The Commission has issued the enclosed Amendment No. 105 to Facility Operating License No. DPR-23 for the H. B. Robinson Steam Electric Plant Unit No. 2. This amendment consists of changes to the Technical Specifications in response to your request dated April 2, 1986.

H. B. ROBINSON STEAM ELECTRIC PLANT, UNIT NO. 2

Amendment No. 105  
License No. DPR-23

SAFETY EVALUATION BY THE OFFICE OF NUCLEAR REACTOR REGULATION  
RELATED TO AMENDMENT NO. 105 TO FACILITY OPERATING LICENSE NO. DPR-23

**FACILITY ORGANIZATION**  
**ROBINSON NUCLEAR PROJECT**  
 Figure 0.2-2

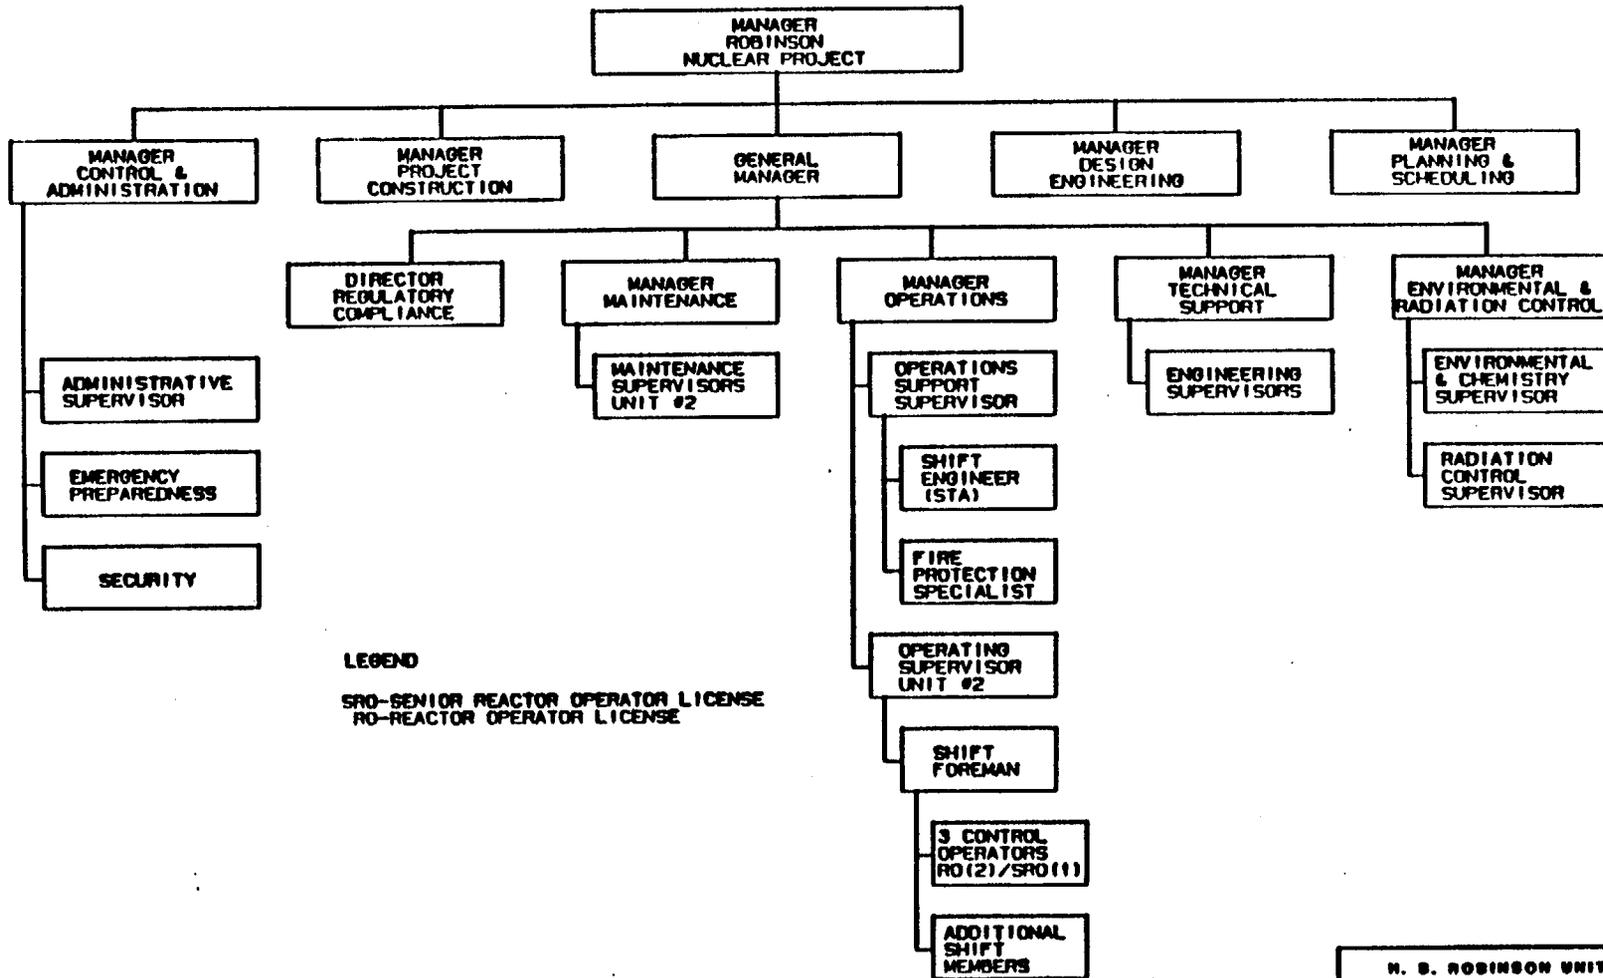
The second requested revision would change the title of "Principal Engineer Operations" to "Operations Support Supervisor" (Figure 6.2-2). Since this is only a title change and does not involve any change in qualifications

or responsibilities, we find it to be acceptable. The submittal indicates that a statement has been added to Section 6.2.3 allowing changes to the organization without a prior license amendment request provided the change request is submitted within three months. We find this additional statement to be unacceptable for the same reason previously stated - it is an implied exemption that has not been justified.
